ADDENDUM # 1

Date: April 26, 2021

LINCOLN STREET PAVEMENT IMPROVEMENTS

21PW01 PH 2

SHEET NO.
C-04
8 OF 15

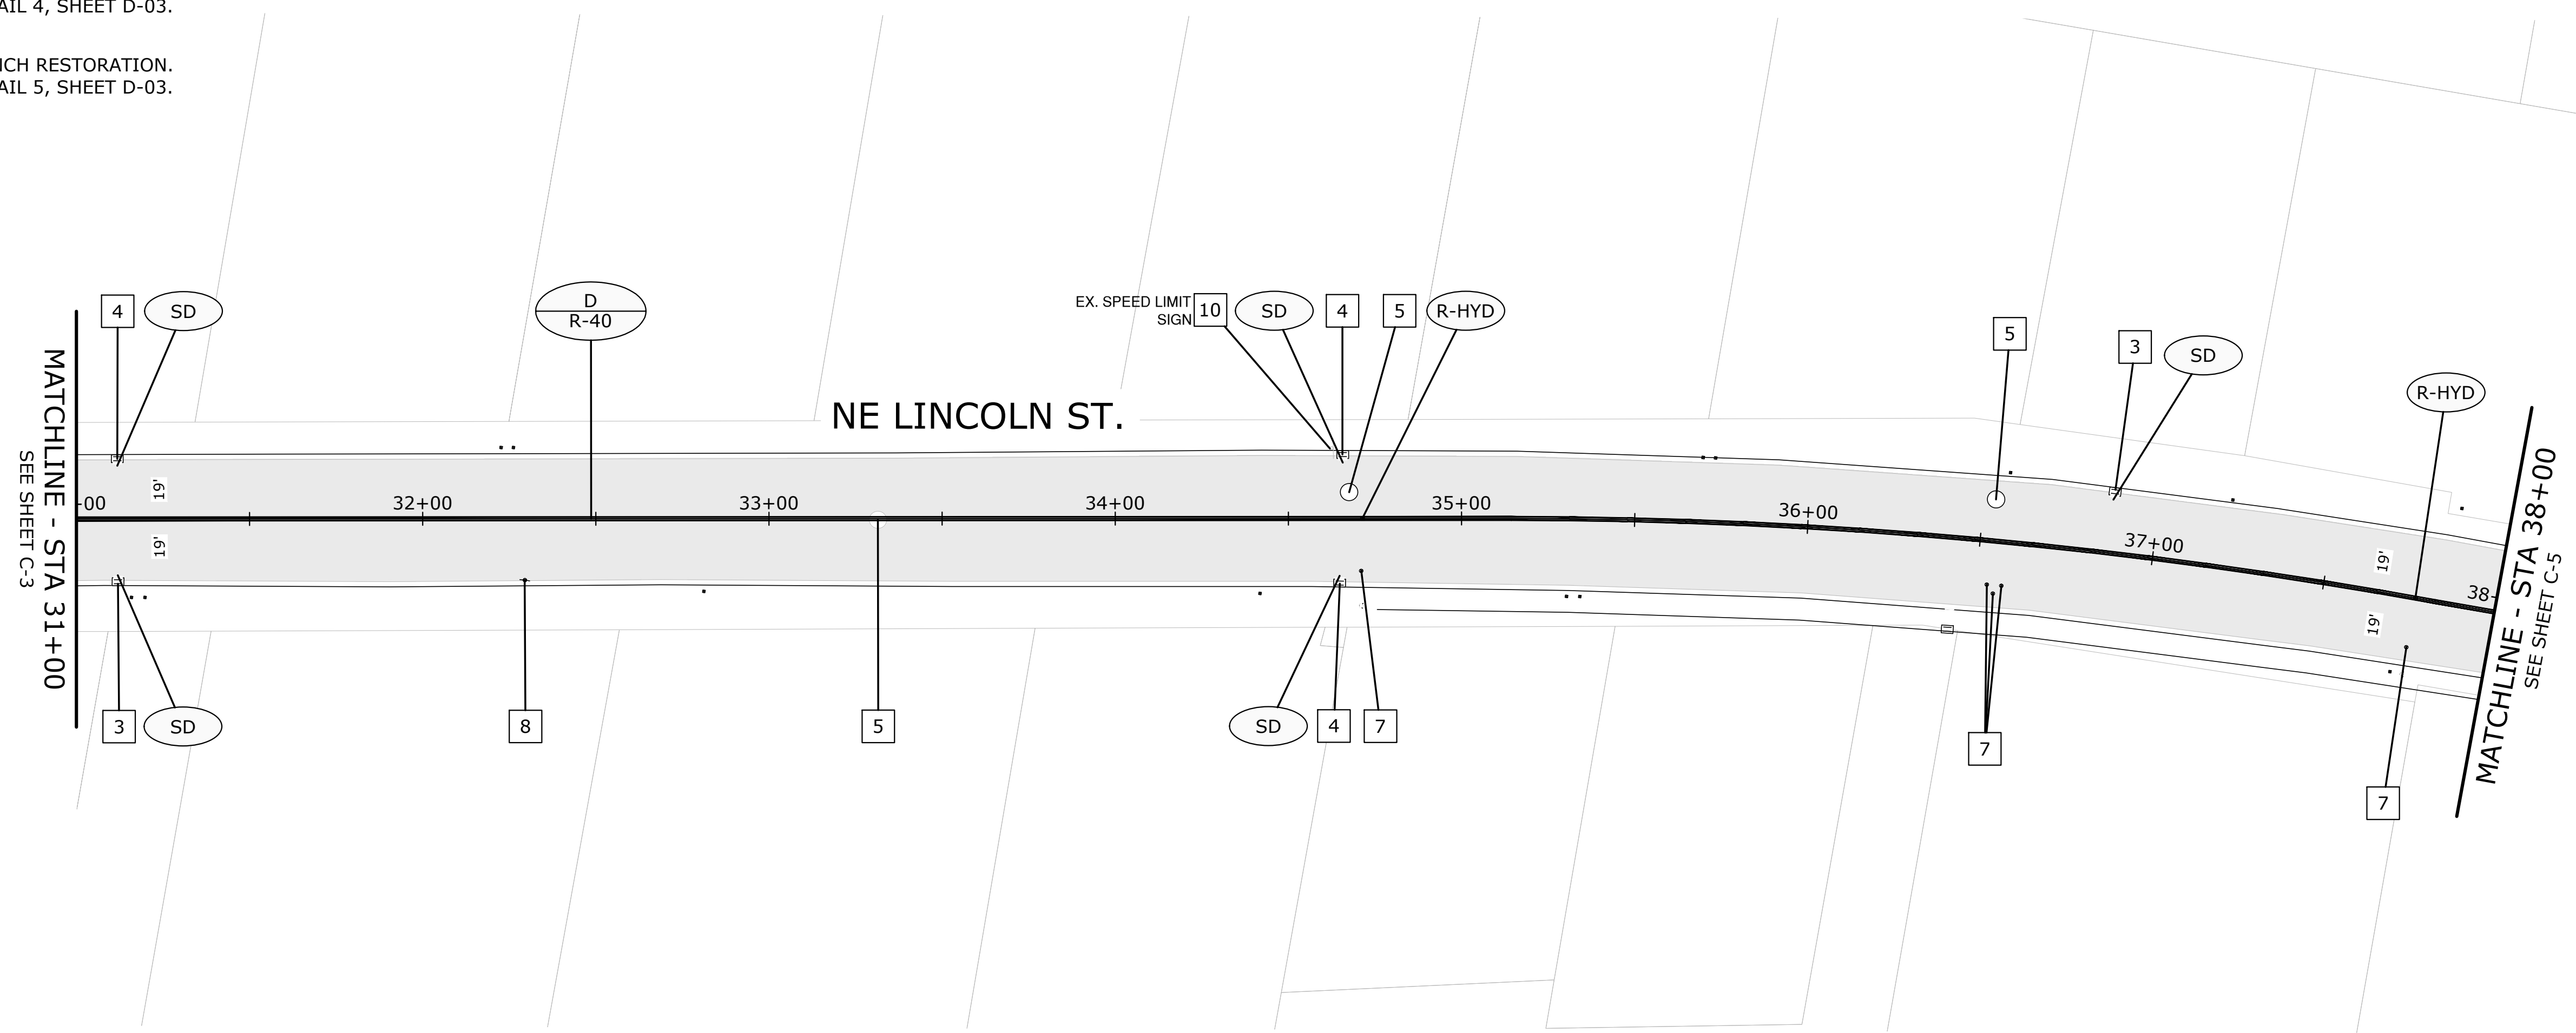
- A. **00744.11(a) Asphalt Cement – MODIFY** the last sentence of this subsection to read as follows: Provide PG 64-22 grade asphalt cement for this Project.
- B. **Bid Form Modifications –**
 - 1. **REVISE** Bid Item #18 quantity to 1,140 SQYD.
 - 2. **REVISE** Bid Item #19 name to “Cold Plane Pavement Removal, 0"-2" Deep (00620)”
 - 3. **REVISE** Bid Item #22 quantity to 8,510 LF.
 - 4. **REVISE** Bid Item #24 quantity to 7 EA.
- C. **REVISE** the following Drawings as noted.
 - 1. Drawings C-04 & C-05; **REMOVE** bike lane striping and bike lane standard stencils.
